Access Compliance Report

Public Rights-of-Way

(Curb Ramps)

Intersection ID: 45981	Main Street: LAUREL_VALLEY_RD	Cross Street: MASON_MILL_PL	Location: SW
ADA ID: A222DE040C96	Ramp Type: PerpDiag	Initial Pass/Fail: Fail	Overall Compliance: No
Severity Score: 22.5			
Codes/Mitigation Info/Possible Solution		Field Measurements/Component Compliance

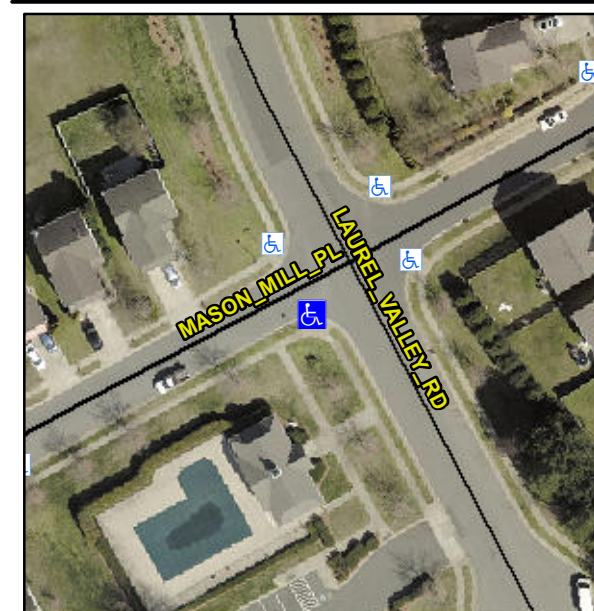
R304.5.1, R304.2.2, R304.5.3

Compliance	Description	Data	Compliance	Description	Data
N/A	Ramp Length (in)	48.0	No	Ramp Slope (%)	9.7
No	Ramp Width (in)	43.0	No	Ramp XSlope (%)	3.7
N/A	Flare Type LT	N/A	N/A	Flare Type RT	N/A
N/A	Flare Slope LT (%)	N/A	N/A	Flare Slope RT (%)	N/A
N/A	Flare Traversable LT?	N/A	N/A	Flare Traversable RT?	N/A
N/A	Landing Length (in)	N/A	N/A	DWS Provided?	N/A
N/A	Landing Width (in)	N/A	N/A	DWS Contrast?	N/A
N/A	Landing Slope (%)	N/A	N/A	DWS Length (in)	N/A
N/A	Landing X Slope (%)	N/A	N/A	DWS Full Width?	N/A
N/A	Landing Curb? (Y/N)	N/A	N/A	DWS Offset (in)	N/A
N/A	Shared Landing?	N/A			
N/A	Gutter Ponding?	N/A	N/A	Gutter Slope (%)	N/A
N/A	Gutter Lip Ht (in)	N/A	N/A	Gutter X Slope (%)	N/A
N/A	Painted X Walk1?	No	N/A	Painted X Walk2?	No
	X Walk 1 Direction	To E		X Walk 2 Direction	To N
N/A	X Walk 1 Width (in)	N/A	N/A	X Walk 2 Width (in)	N/A
	X Walk 1 Slope (%)	3.9		X Walk 2 Slope (%)	3.9
	X Walk 1 X Slope (%)	1.8		X Walk 2 X Slope (%)	4.2

N/A	Ramp inside XWalk1?	N/A	N/A	Ramp inside XWalk2?	N/A
	Road Slope (%)	2.0	N/A	Clear Space?	N/A
	Road X Slope (%)	5.9	N/A	Clear Space to XWalk (in)	N/A
N/A	Any Obstructions?	N/A	N/A	Storm Grate/Utility Hazard?	N/A
	Obstruction Type			Storm Grate/Utility Type	
		N/A			N/A
			Yes	Surface Condition? (G/P)	Good

Remove & Replace Curb Ramp With Two New Directional Ramps or Equivalent.
